Service Note		
Product	Description:	Service note no.
BH500 Powerboard	Condensing sensitivity	SNo-T138

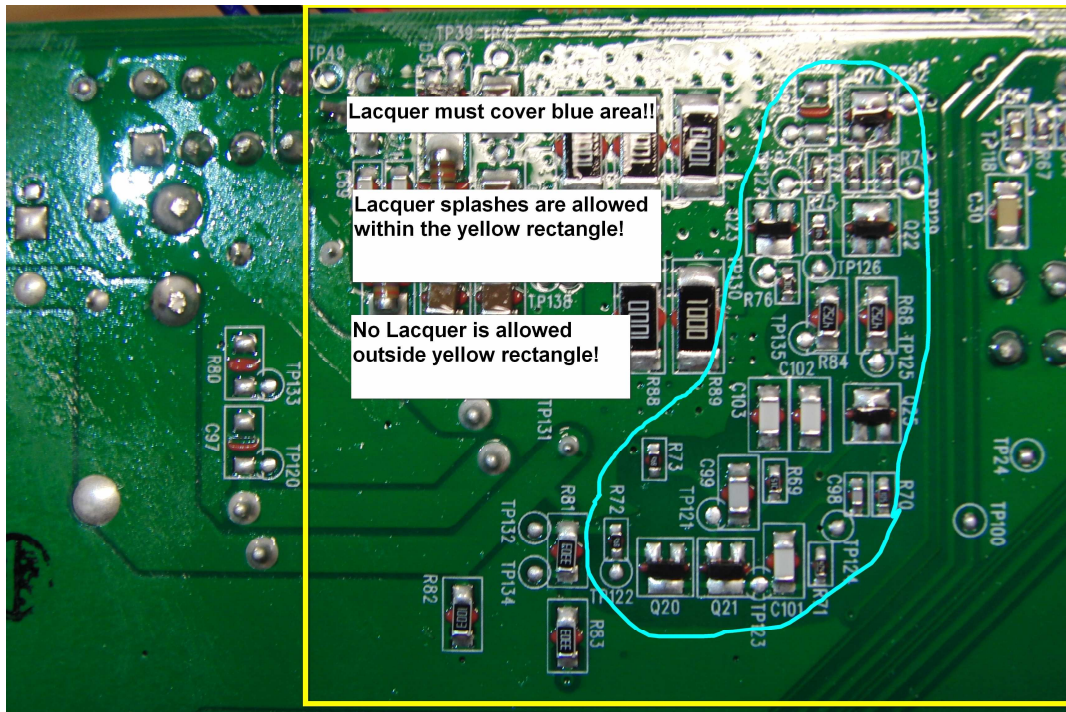
Powerboard P18412-Bxx is sensitive to condensation which can trigger the overcurrent protection. To improve this issue, a procedure is implemented where lacquer is sealing the sensitive control components. Products with serial number 11376941 and forward have had the Powerboard lacquered from the factory. Some products with lower serial numbers might also have been lacquered, but if not the board must be lacquered when the product is in for service.

Note : a bit of lacquer splash are accepted within the yellow region.

Lacquer type : 1B73 Acrylic Coating, UL number E 105698, www.humiseal.com, Thickness : 100-300u meter.
